**RE: Preliminary and Final Major Site Plan
Proposed Use: Industrial/Warehouse/Office
536-544 Washington Avenue
Block/Lot: 1502/12**

To: Township of Nutley Planning Board
From: Matthew Clark
Date: 05/13/2026
Subject: 536-544 Washington Avenue
(Site Plan Checklist Waiver Comments); Site Plan Application

DATE	REVISIONS
TITLE SHEET	
536-544 WASHINGTON AVENUE	
BLOCK 1502 - LOT 12 TOWNSHIP OF NUTLEY ESSEX COUNTY, NEW JERSEY	
MCB ENGINEERING ASSOCIATES, LLC	
P.O. BOX 588, 11 FURLER STREET TOWANA, NEW JERSEY 07511-0588 PHONE: (973) 812-6680 - FACSIMILE: (973) 812-6681 Certificate of Authorization No.: 24628108300	
scale AS NOTED	date 03/18/2026
project no. 4703	sheet no. 1 OF 10

scale 1" = 20' date 03/18/2026 project no. 4703 sheet no. 4 OF 10

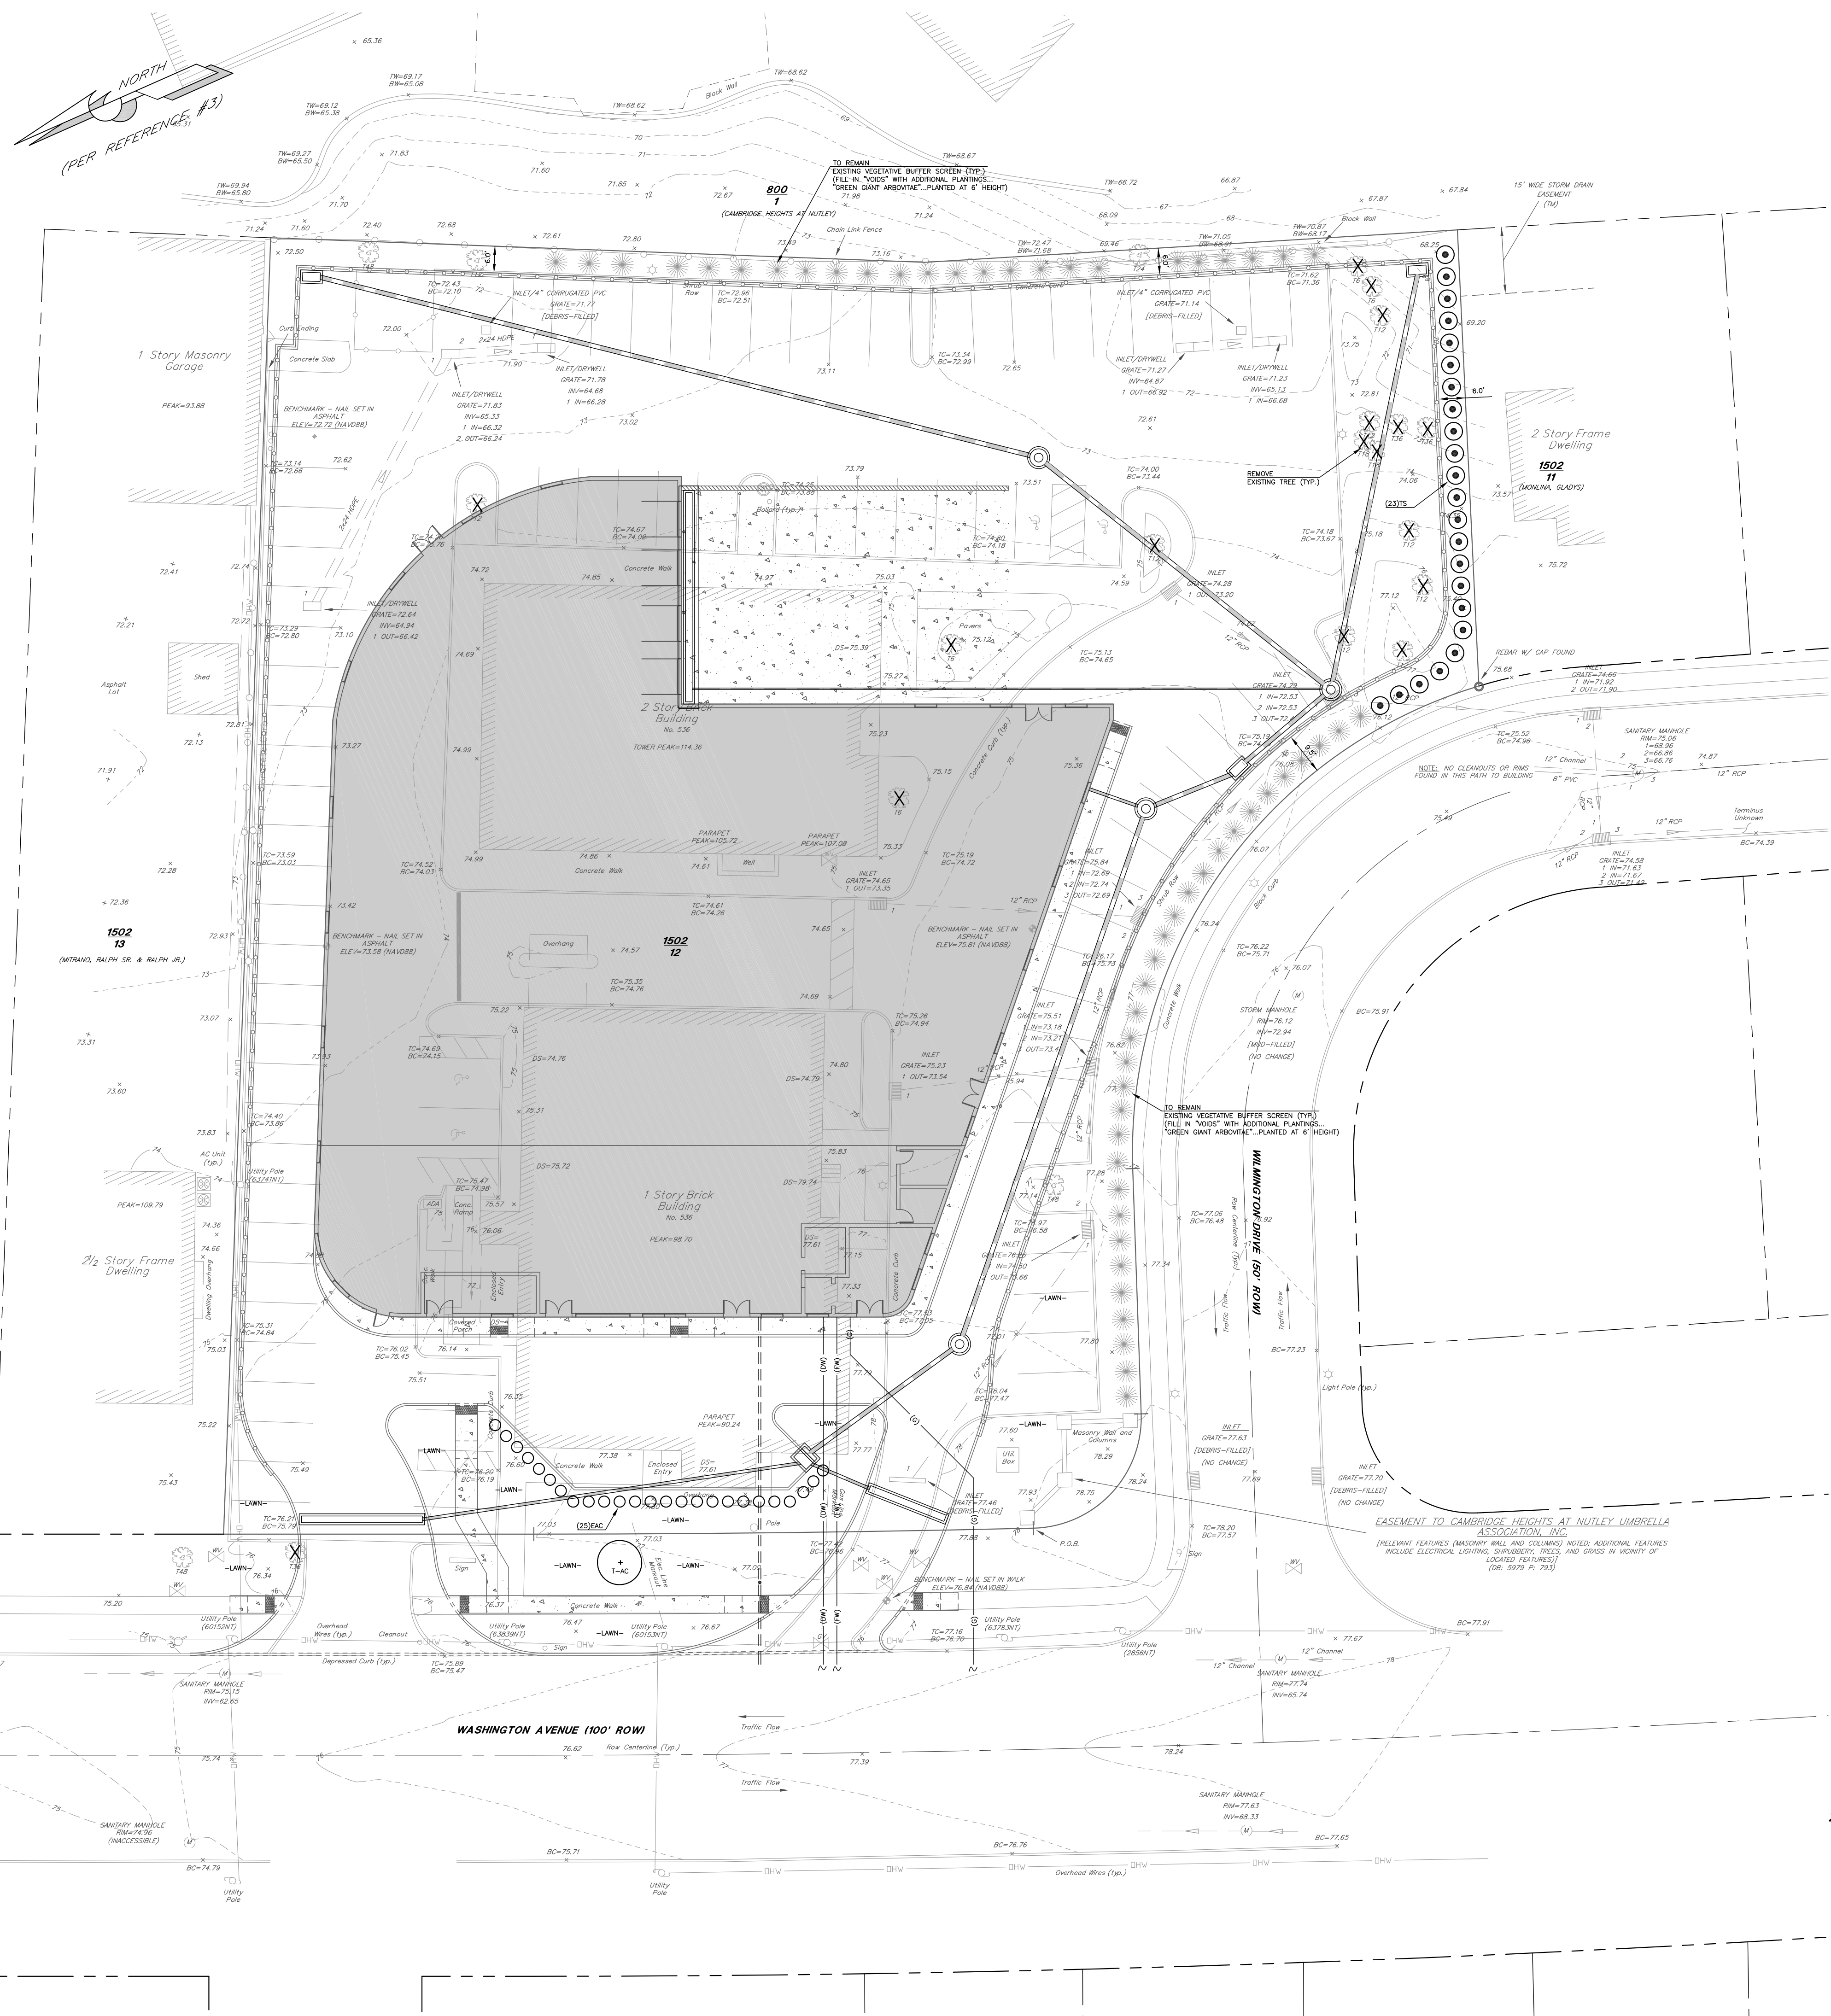
LIGHTING PLAN COMMENTS (SHEET 4)

- 1) The Lighting Plan shows the proposed exterior lighting via seven pole mounted fixtures and eight building mounted fixtures with a maximum mounting height of 15 feet and a maximum illumination along the property lines of 0.1 footcandles. We have no objection to lighting plan proposed; no response necessary.
- 2) The proposed parking configuration should be shown as the background on the Lighting Plan (Sheet 4).
- 3) Applicant should provide testimony regarding hours of operation of the lighting and should provide results of testimony as a note on the Site Plan.
- 4) It appears that no new street lighting is proposed; this should be confirmed via applicant testimony at the Planning Board.
